**geo - logic** *geotechnical and environmental consulting services*

**RE: Revisions to Work Plan for Soil and Groundwater Investigation  
Allied Engineering Co., 2421 Blanding Avenue, Alameda, CA  
Fuel Leak Case No. RO0002601**

# Site Plan - Proposed Boring Locations

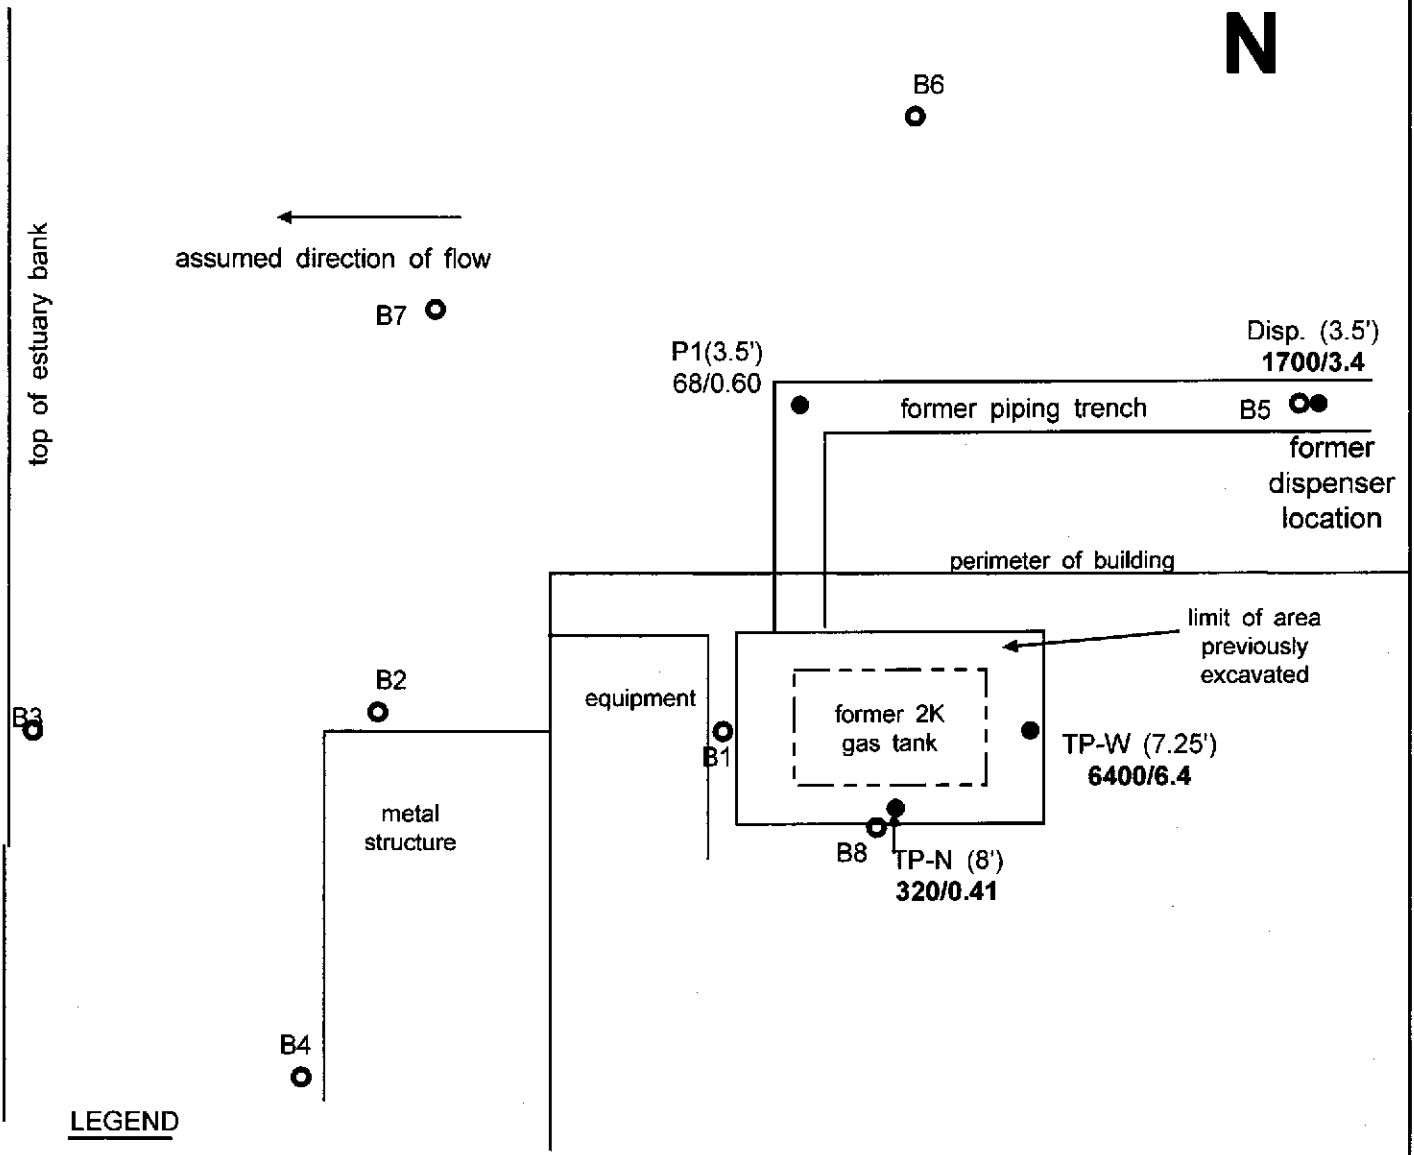
Technical Comment No. 1 - An additional boring (B8) will be located adjacent to the south sidewall of the former tank pit, as shown on the revised Figure 1 (attached). Soils will be screened with a PID during drilling. If no staining, odor, or elevated PID readings are observed, soil samples will be collected from each boring at five feet bgs, at the capillary fringe immediately above the zone where groundwater is first encountered, and 12 to 15 bgs. Grab groundwater samples will also be collected.
